Re: Indian Point Unit No. 2
Docket No. 50-247

Subject: Response to Request for Additional Information - Generic Letter 96-06, "Assurance of Equipment Operability and Containment Integrity During Design Basis Accident Conditions," for Indian Point Unit No. 2. (TAC No. M96822)

RESPONSE TO REQUEST FOR ADDITIONAL INFORMATION
REGARDING RESPONSE TO GENERIC LETTER 96-06

Drawing No. WREF-PO-4-SS-1

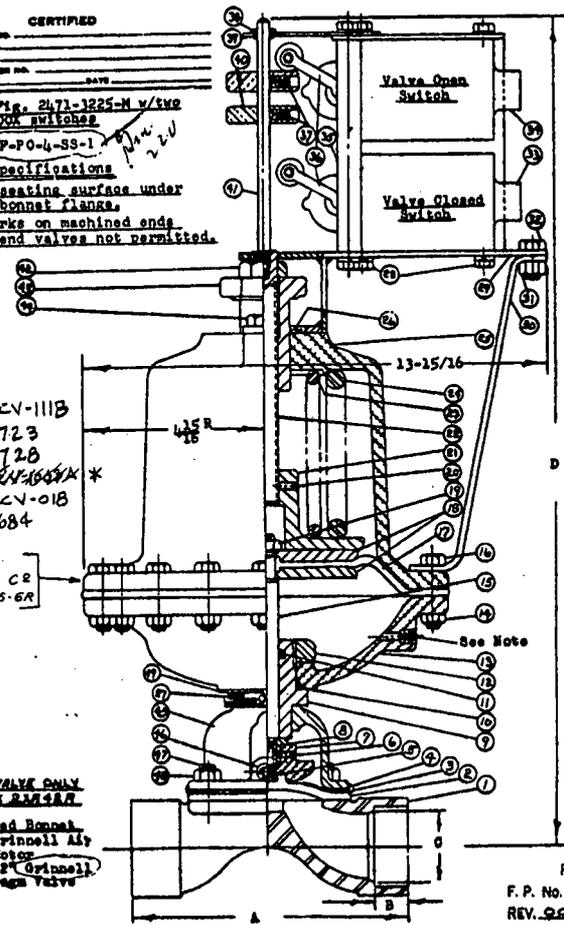
“Please provide drawings of these valves, the calculations used to determine the lift pressure and discuss any sources of uncertainty associated with the calculated lift pressure.”

Attachments 1 and 2 are drawings of the 2" and 3" Grinnell diaphragm valves used on lines 33, 40 and 338 which would lift and prevent internal line pressure from exceeding UFSAR allowable stress limits. For line 33, valve 560 would lift at a minimum line pressure of 207 psig and vent to the pressurizer relief tank. Valve 560 is a 3" Grinnell diaphragm valve as shown on drawing No. WREF-PO-5-SS-1. For line 40, valves 1702 and 1705 would lift at a minimum line pressure of 207 psig and vent any line pressure to the Hold-Up Tanks. Both valves 1702 and 1705 are 3" Grinnell diaphragm valves as shown on drawing No. WREF-PO-5-SS-1. For line 338, valves 1723 and 1728 would lift at a minimum line pressure of 271 psig and vent any line pressure to the Hold-Up Tanks. Both valves 1723 and 1728 are 2" Grinnell diaphragm valves as shown on drawing No. WREP-PO-4-SS-1.

3. For the 2" valve with 3225 air motor, 101 and 102A springs (drawing WREF-PO-4-SS-1), the minimum valve line pressure to open the valve was found to be ~~200~~ ^{271 psig max.} psig. The comments concerning the analysis and variables apply to this configuration as well. The 102A spring, which is the spring we would use if the valve was being supplied today, was used for calculations since no data on the 102 spring could be found. The 102 spring has not been used for many years and the only information we can find on it is that for sizing an actuator, the maximum line pressure for the 102 and 102A springs are the same.
